From: "Lindgren, Donald A." <lindg1da@westinghouse.com>
To: "jnw@nrc.gov" <jnw@nrc.gov>
Date: Wed, Oct 12, 2005 3:17 PM
Subject: AP1000 Tier 1 Change Comment Responses

PROPOSED REVISION 15
AP1000 DESIGN CONTROL DOCUMENT

Tier 1 Subsection 2.1.3; Tables 2.1.3-1, 2.1.3-2, 2.1.3-3, and 2.1.3-4; and Figure 2.1.3-3
Reactor System

Figure 2.1.3-3
Reactor Vessel Arrangement

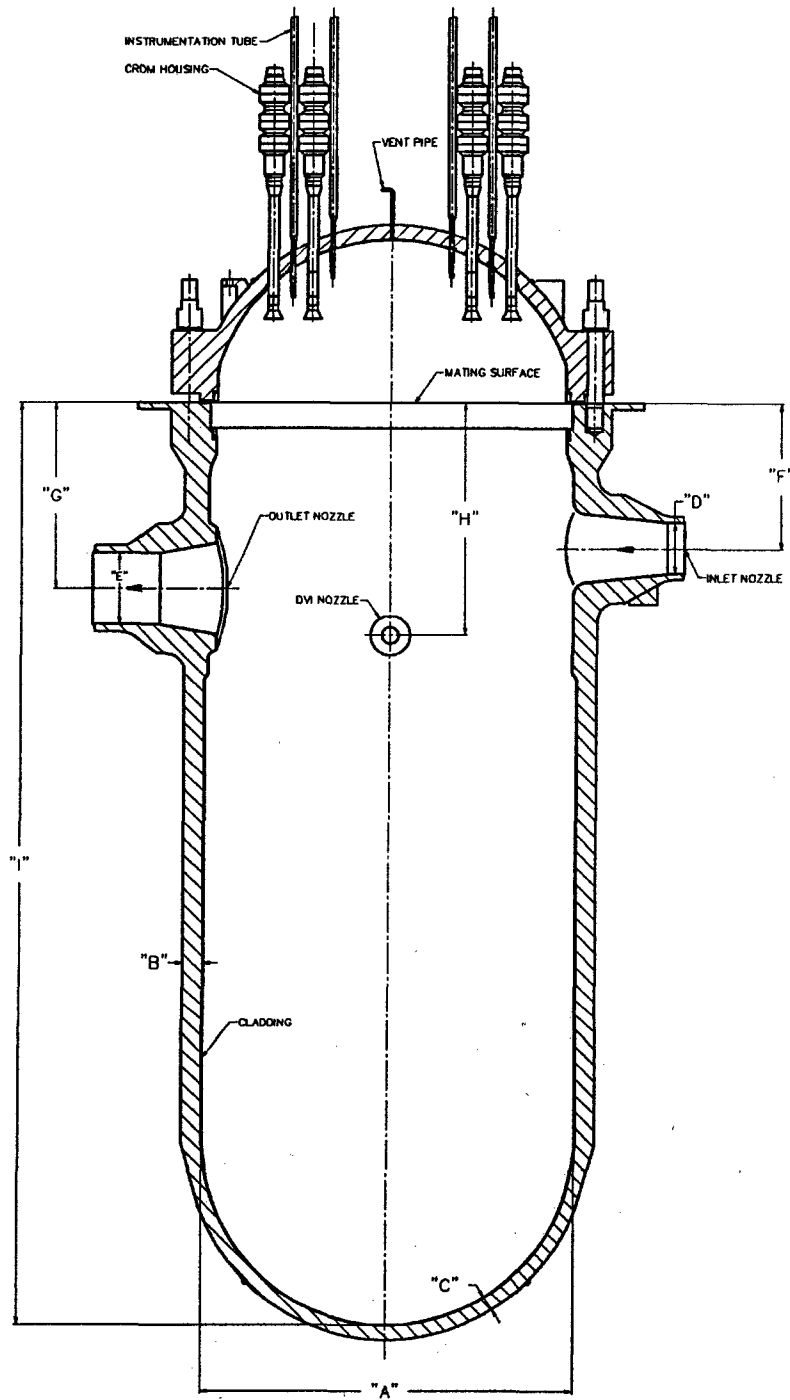
Comment: In figure 2.1.3-4 we changed the reactor vessel diameter. Tier 2 needs to be changed to be consistent.

Tier 1 Figure 2.1.3-3 Revise Tier 1 Figure 2.1.3-3 as shown on the next page.

Tier 2 Table 1.3-1 and 5.3-5, Subsection 5.3.1.2 and 5.3.4.1, and Figure 5.3-1 and 5.3-6 will be revised to be consistent with the changes in Tier 1 text and figures. A revised write-up for 2.1.3 is attached that shows the revised changes and includes the proposed Tier 2 changes (figures later) is attached.

The changes to GRCA tag numbers are corrections of the tag numbers. The change to Table 2.1.3-2 Item 7 is to clarify the first unit testing. The change to Tier 1 Table 2.1.3-2 Item 9 is to provide a precise reference for an ITAAC item. The change to vessel diameter is due to progress in detail design and supporting analysis. Editorial changes are self-evident.

Most of the changes reflect current fabrication practices; for example, a one-piece forged reactor vessel head is the standard replacement head configuration. The increase in vessel inside diameter in the core region by 2 inches helps to decrease the fluence on the vessel. The decrease in the vessel wall thickness near the nozzles makes welding the nozzles easier, and the resulting wall thickness is the same as in the Westinghouse Standard 3XL reactor vessels.
